SITE PLAN FOR PLANNING COMMISSION
EXISTING CONDITIONS

1201, 1209, 1213 SOUTH UNIVERSITY
CITY OF ANN ARBOR FILE #SP24-0020

SITE PLAN FOR PLANNING COMMISSION
SITE LAYOUT PLAN

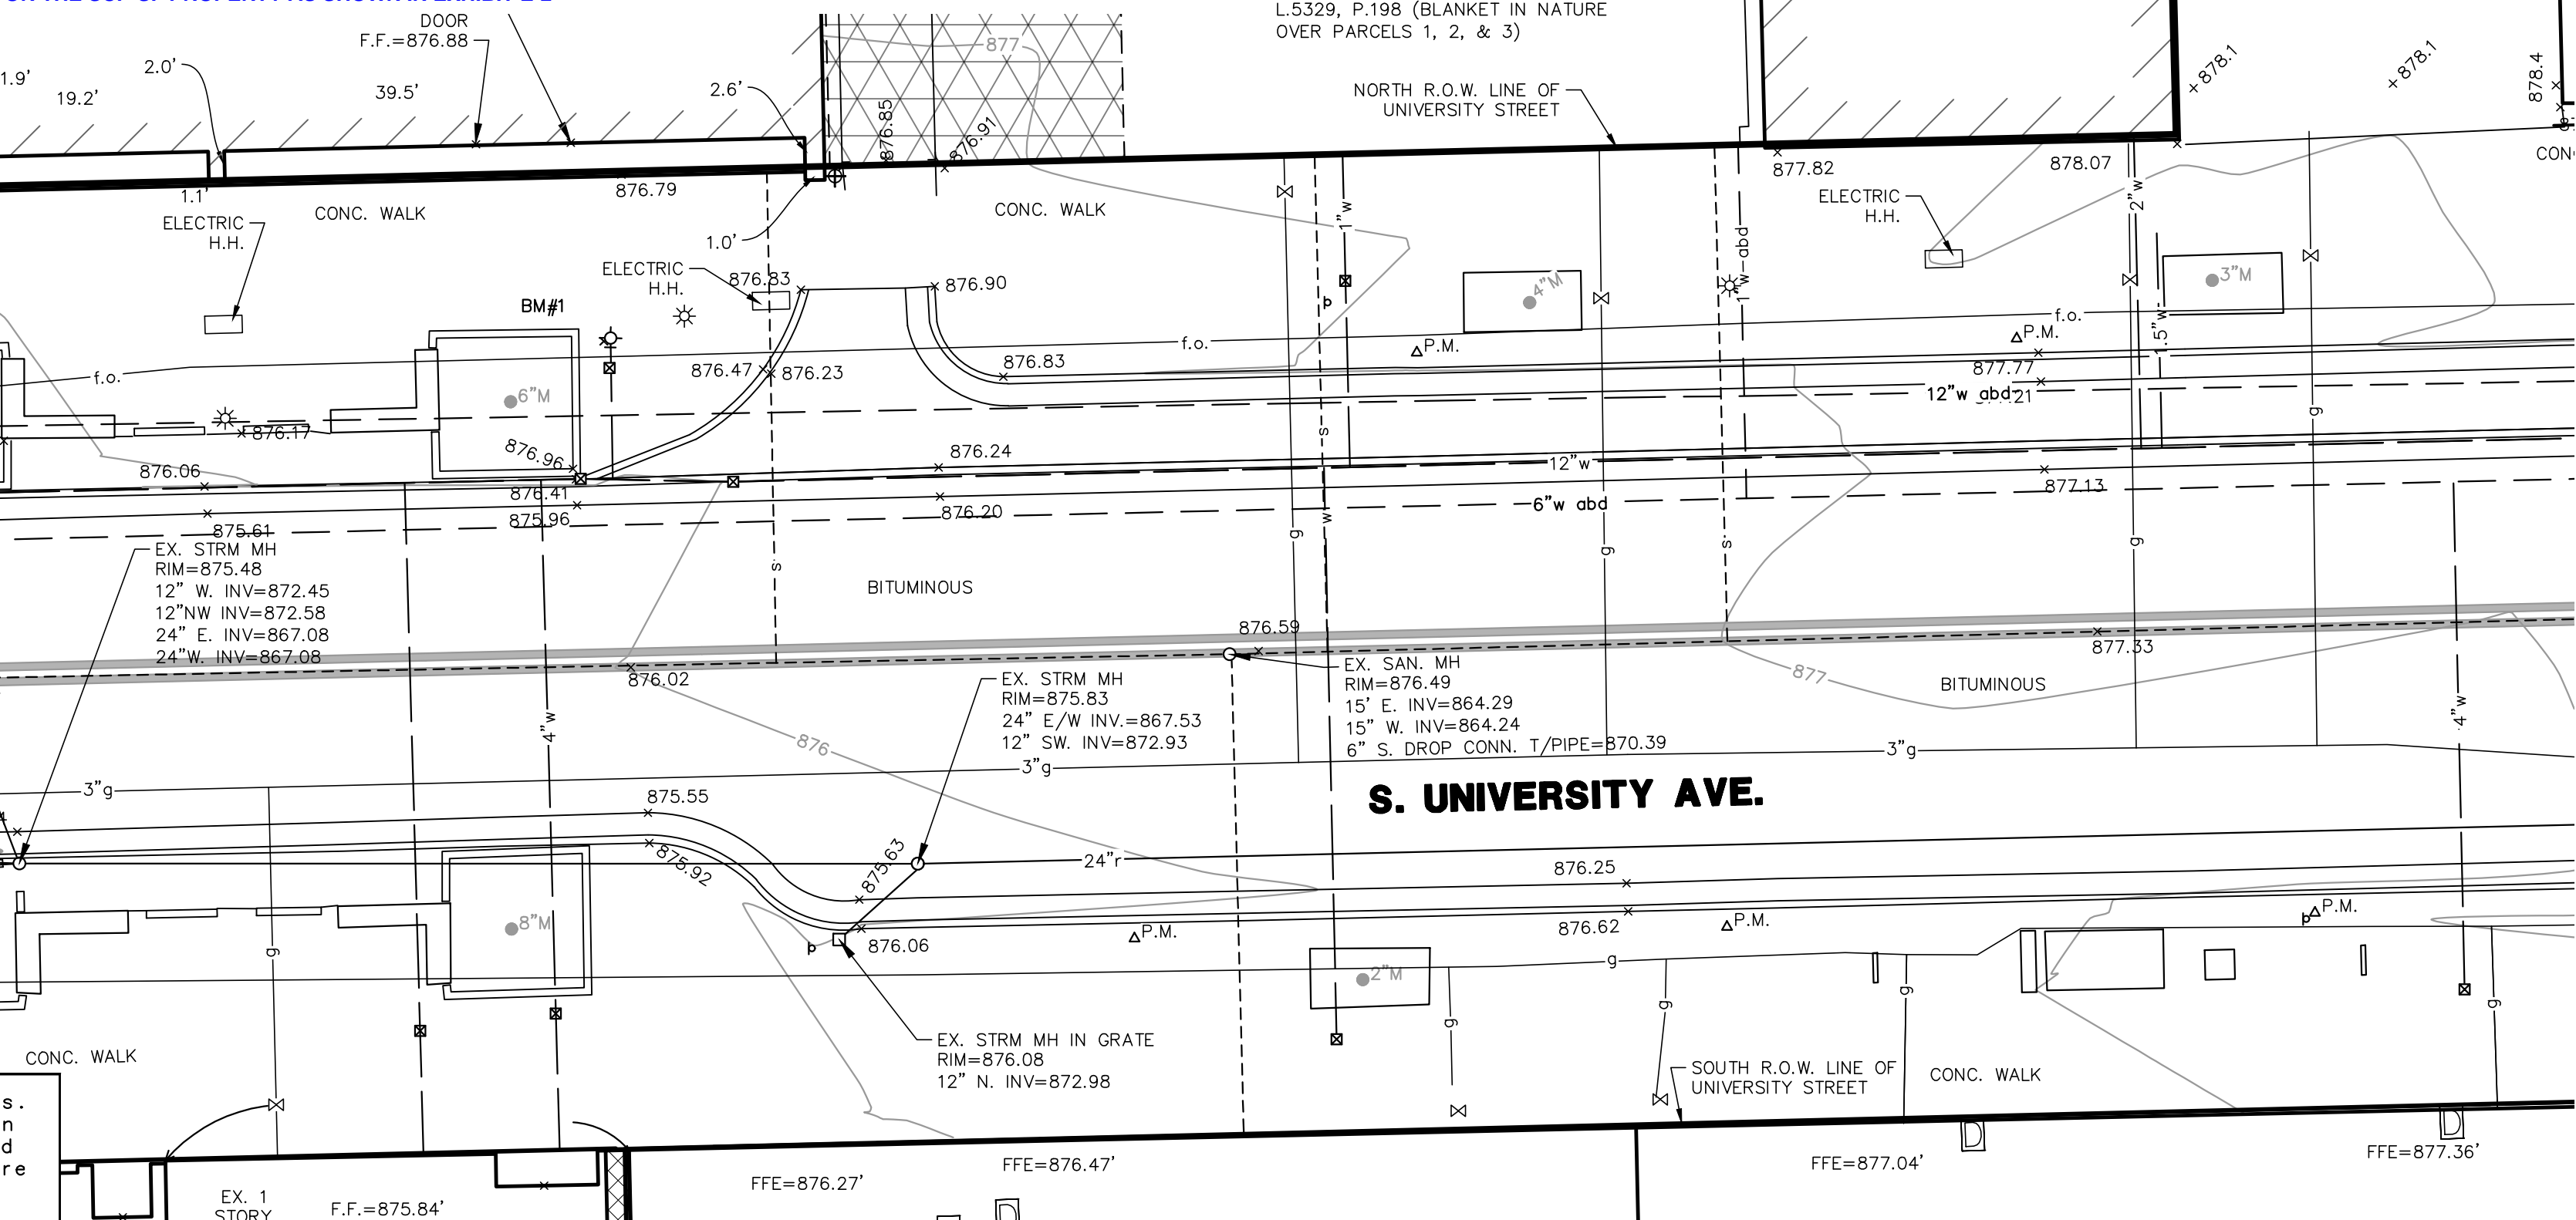
- The northernmost boundary of the SCP-SF access easement is legally described as 41.63'. The Proposed Development illustrates only 41.38' between the eastern property line and the bike room. See page 8 of the Site Plan. The two western columns illustrated on page 8 of the Site Plan are an additional encroachment upon the access easement.

- The eastern two columns illustrated on the Site Plan (see page 8), will completely block access to the SCP-SF parcel.
- A fifth column to the east of the "Proposed Sliding Gate" appears to encroach upon access easement. See Page 8 of the Site Plan.

- The southernmost boundary of the SCP-SF access easement, the entrance from S. University Avenue, is described as being 20.24 feet long in the Easement Agreement. The Proposed Development describes this boundary as 22' (see page 8 of the Site Plan) but then narrows access to 19.5' via the installation of bollards on the access easement. Although the entranceway bollards are indicated as being retractable, those within the easement are not.

- The easternmost boundary of the access easement, starting from S. University Ave. is described as being 68.00'. The Proposed Development describes this boundary as only 66.96'.

- The bollards behind the refuse staging area (see page 8 of the Site Plans) are not illustrated as being retractable. This would act as a complete barricade to vehicular access to the SCP-SF parcel.

- The Site Plans illustrate proposed concrete pavement on a portion of the access easement in the northeast corner of the Proposed Development but also illustrate proposed concrete walk on another portion. SCP-SF interprets this to mean that vehicles will not be allowed on the concrete walk portion of the access easement. The access easement provides both pedestrian and vehicular access over its described area, including that illustrated as being a concrete walk.

- There is a question of height clearance with regard to that portion of the access easement illustrated as concrete walk. The concrete pavement portion of the access easement is illustrated as having at least 25' of vertical clearance (see page SP1.01 of the Site Plan). That portion of the Proposed Development over the concrete walk portion of the access easement illustrates development of a generator and emergency electrical room on the second level (see SP2.02 of the Site Plan).

BUILDING DESIGN TO BE MODIFIED TO ELIMINATE ENCROACHMENT

CURRENTLY PROPOSED COLUMNS WOULD NOT BE ANY MORE RESTRICTIVE THAN THE TWO COLUMNS FROM PREVIOUS DEVELOPMENT

SEE SHEET 08 OF THE SITE PLAN SET. PROPOSED COLUMN DOES NOT ENCROACH

PREVIOUS DEVELOPMENT PROVIDED 18' MIN. CLEAR WIDTH BETWEEN BOLLARDS/CURBING. CURRENT PLAN PROVIDES 18.25' CLEAR WIDTH FROM EDGE OF EAST BOLLARDS TO WEST EDGE OF EXISTING EASEMENT

THERE ARE TWO PARTICULAR DIMENSIONS SHOWN ON SHEET 08 (60.96' AND 6'). THESE DIMENSIONS REPRESENT THE NORTH-SOUTH DIMENSION OF THE BUILDING, AND THE CLEAR WIDTH FROM NORTH FACE OF BUILDING TO SOUTH FACE OF EXISTING RETAINING WALL, RESPECTIVELY. IT APPEARS THE PARTY CONTESTING THE DESIGN HAS FAILED TO ACCOUNT FOR THE 0.19' DIMENSION ALSO SHOWN ON SHEET 08 OF THE CURRENT PLANS, WHICH REPRESENTS THE PROPOSED BUILDING SETBACK FROM SOUTH PROPERTY LINE, AS WELL AS THE THICKNESS OF THE EXISTING RETAINING WALL THAT HAS ITS NORTH EDGE ON THE NORTH PROPERTY LINE.

THESE CAN BE DESIGNED AS REMOVABLE BOLLARDS. IT SEEMS THESE BOLLARDS WOULD BE NO MORE RESTRICTIVE THAN THE BUMPER BLOCKS, PARKED VEHICLES, AND RETAINING WALL THAT WERE INCLUDED IN THE PREVIOUS DEVELOPMENT.

THE PLANS ARE TO BE MODIFIED TO SHOW THE SAME CONCRETE PAVEMENT SECTION PROVIDED THROUGHOUT THE ENTIRE SCP-SF ACCESS EASEMENT

15' MIN. VERTICAL CLEARANCE IS PROPOSED THROUGHOUT THE SCP-SF ACCESS EASEMENT AREA

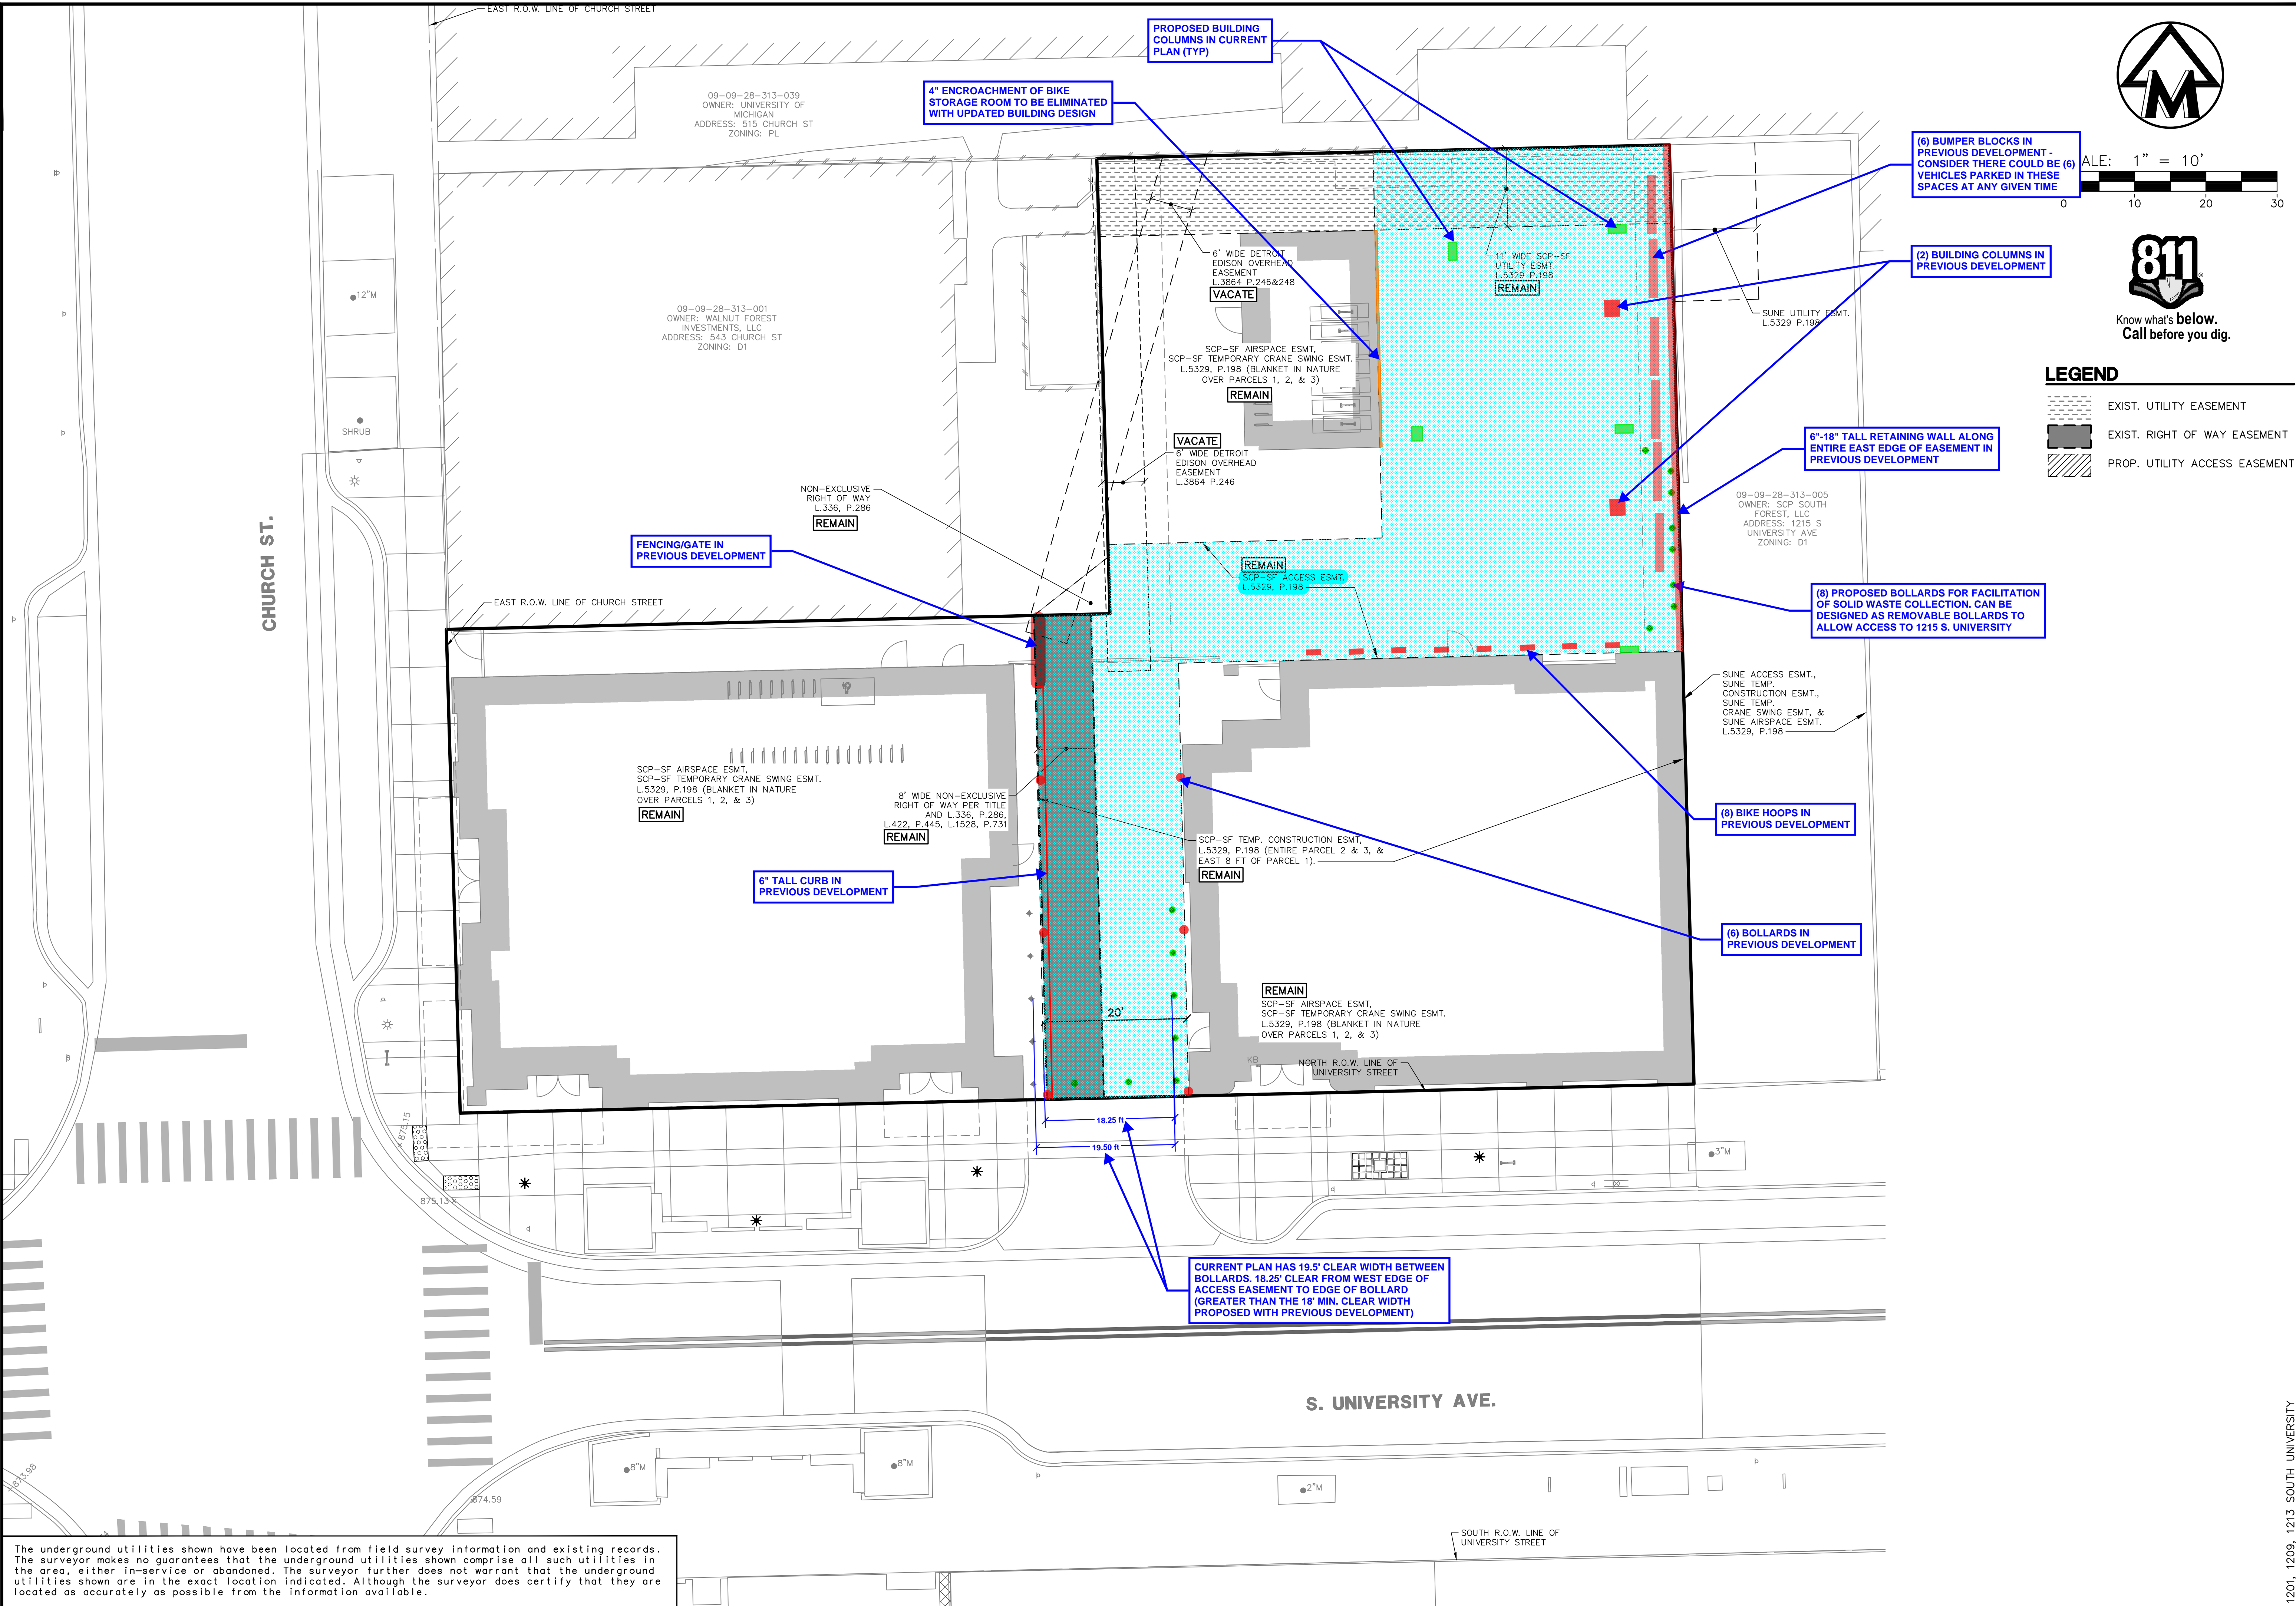
- The Proposed Development illustrates a "Snow Storage Area" directly in the middle of the northernmost portion of the access easement (see page L1.100 of the Site Plan). This would be a complete obstruction to access to the SCP-SF parcel in the winter months.

THE EXPECTATION IS THAT THERE WILL BE VERY MINIMAL SNOW ACCUMULATION ACROSS THE GROUND LEVEL OF THE DEVELOPMENT DUE TO A MAJORITY OF THE SITE BEING COVERED BY BUILDING ABOVE. THE SNOW STORAGE AREA SHOWN ON SP1.01 IS LIKELY MUCH LARGER THAN WHAT IS ANTICIPATED. THE PLANS CAN BE MODIFIED TO SHOW A MORE ACCURATE REPRESENTATIVE AREA THAT IS ALSO ORIENTED CLOSER AND ALONG THE BIKE STORAGE ROOM WHICH WOULD MAXIMIZE THE CLEAR AREA MAINTAINED IN THE EASEMENT.
